FIRST REVIEW
WC³ Project #: 218-525-099
Weber County

Subject: Morar - SFD – Plan Review Comments 1st Review

Project Name: Morar - SFD

Location(s): Ridge Nest 14r, Eden, UT

S3. Sheet S1.2:

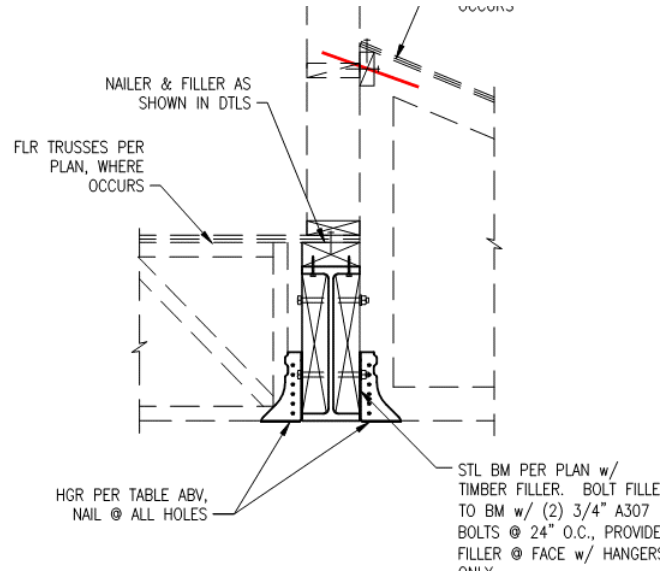
- A. Typical Truss Hangers: Cross grain bending may occur at ledger. Face nailing may also experience pull out forces. Please consider adding tension devices and blocking at suitable spacing to transfer transverse loads to the interior studs. (ASCE 7 12.11.2.2, 1.4, 12.1.3, 12.10.)

S4. Sheet S3:

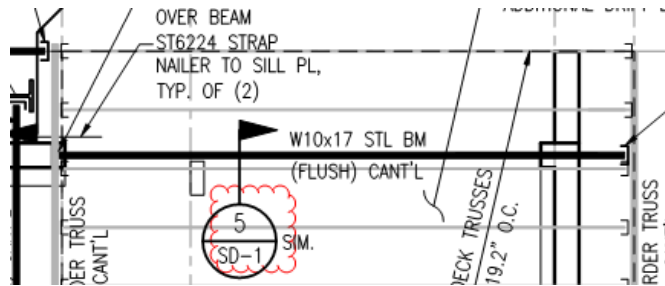
- A. Main Floor Framing: Detail 5/SD-1 does not appear to be applicable for the shown condition. Please verify and revise as required. (IBC 107)

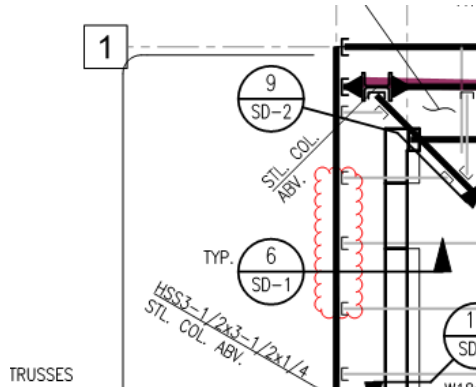
- B. GL-1, A: Beam information appears to be missing. Please verify and indicate on the drawing. (IBC 107)

- A. Detail 1:

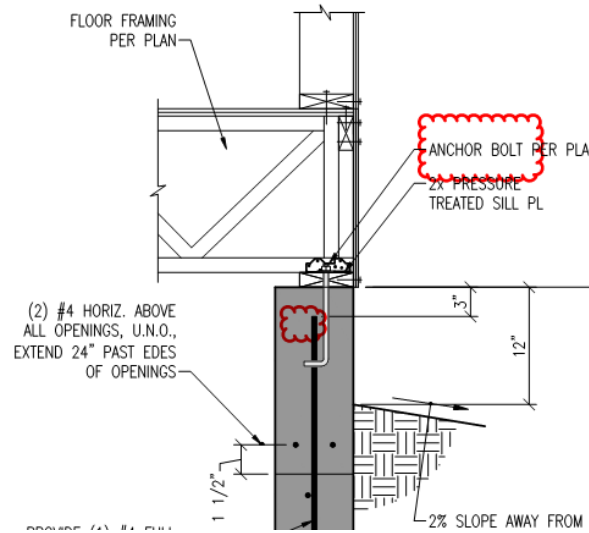
- I. Please verify that anchor bolt spacing on the plan has included consideration for restraint retaining wall condition. (IBC 1604)
- II. Please verify if continuous reinforcements are missing at anchor bolts location. Otherwise, please provide analysis for restraint condition of the retaining wall showing how the retained loads are transferred to the anchor bolts. (IBC 1604)

B. Detail 11:

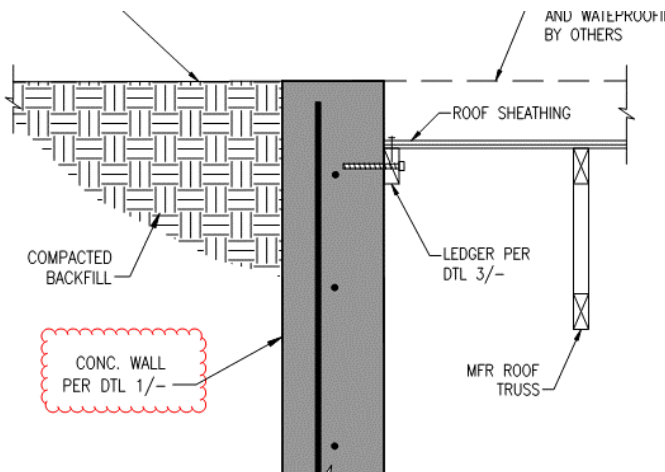
- I. The detail appears to show an unrestraint retaining wall. The reference to Detail 1 is for restraint condition. Please verify if the intent was for restraint condition and provide blocking at suitable spacing to transfer loads into the diaphragm. (IBC 107)
- II. Cross grain bending may occur at ledger. Please consider adding tension devices and blocking at suitable spacing to transfer transverse loads to the concrete wall. (ASCE 7 12.11.2.2, 1.4, 12.1.3, 12.10.)

Special RC Shear Wall Checks per 18.10 (1.2-1ST)

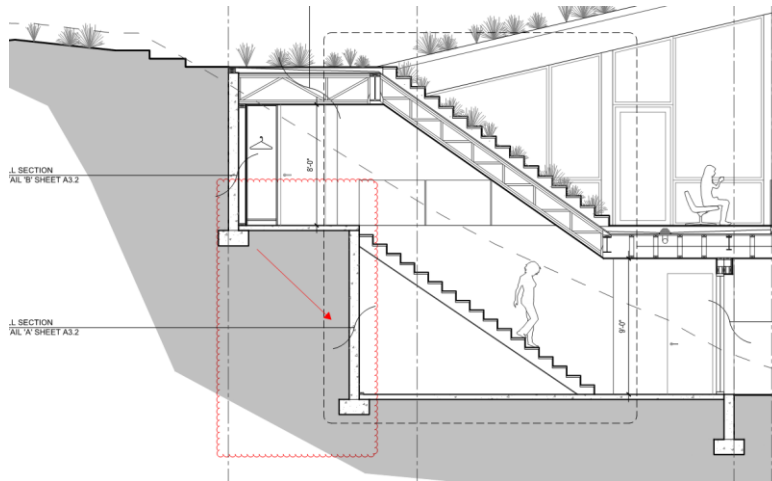
- A. Please provide details for the special reinforced shear wall. (ACI 318 18.10)
- B. At least 2 curtains of reinforcement shall be used in a wall if $h_w/l_w \geq 2.0$. Please verify and revise as required. (ACI 318 18.10.2.2)
